ARKANSAS NUCLEAR ONE - UNIT 1

IMPROVED TECHNICAL SPECIFICATIONS SUBMITTAL

**03/19/01 Supplement
Volume 1 of 2
(Sections 3.4A, 3.4B, and 3.5)**

March 19, 2001

Fig 3.4.3-3

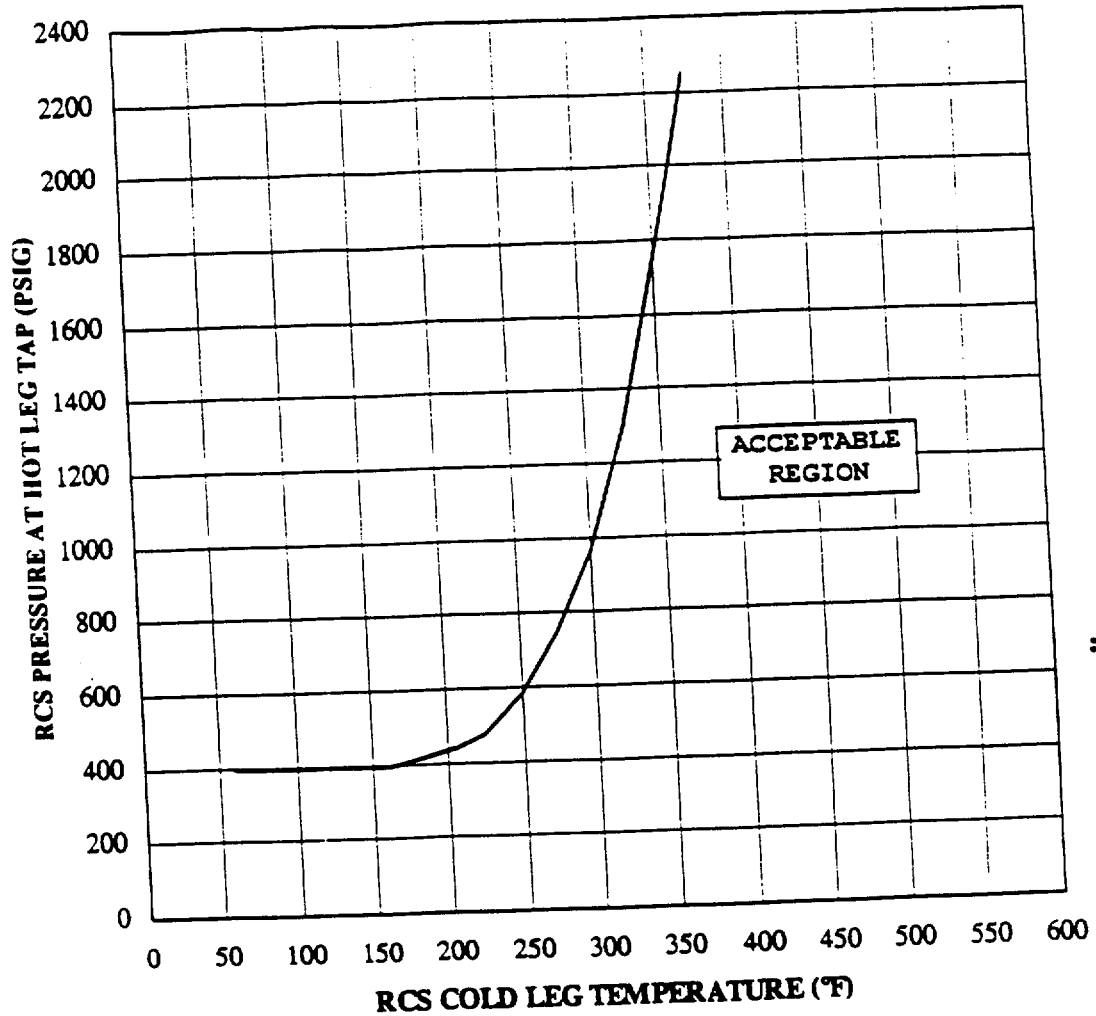
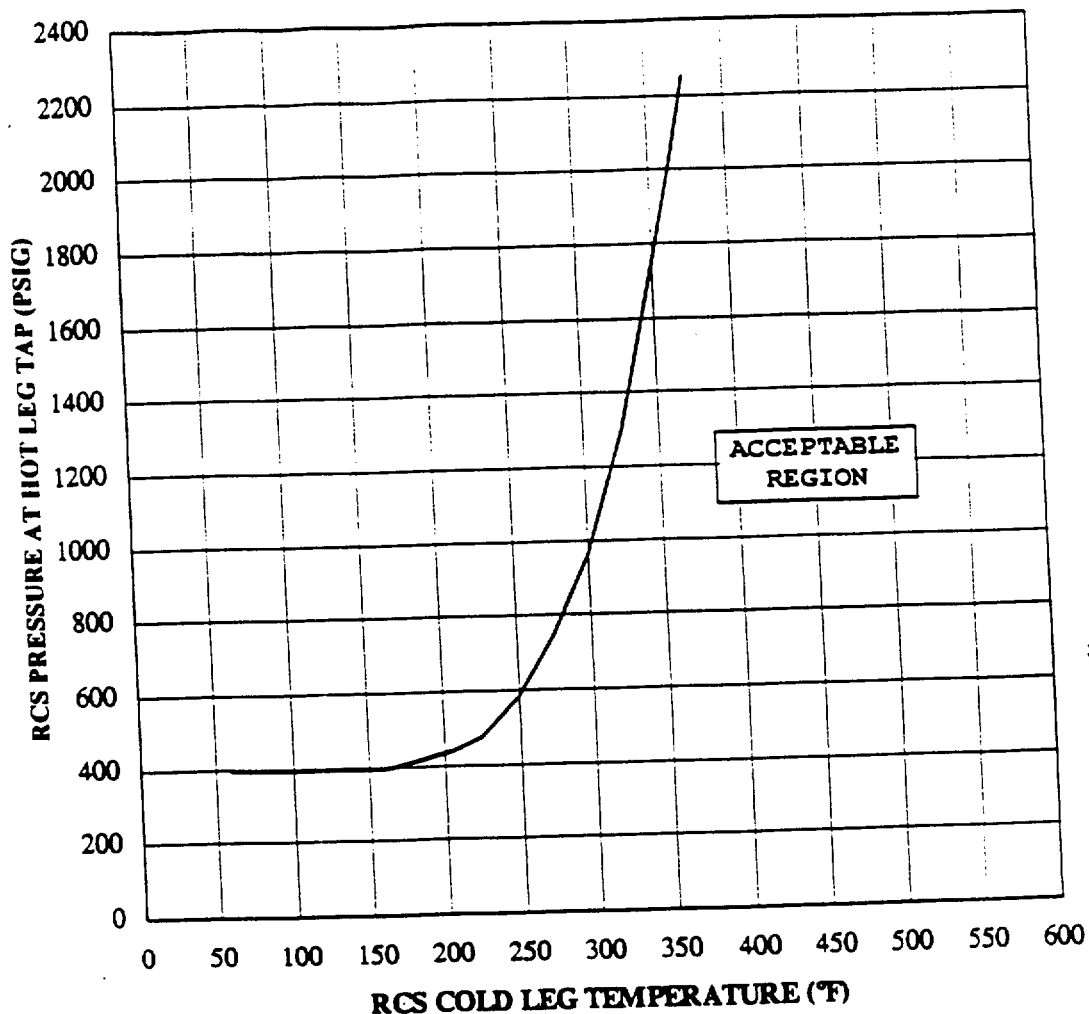
A2

Reviewer's Note: These inserts are revised versions
of CTS Figures 3.1.2-2, 3.1.2-3, and 3.1.2-1. They are,
respectively, ITS Figures 3.4.3-1, 3.4.3-2, and 3.4.3-3.
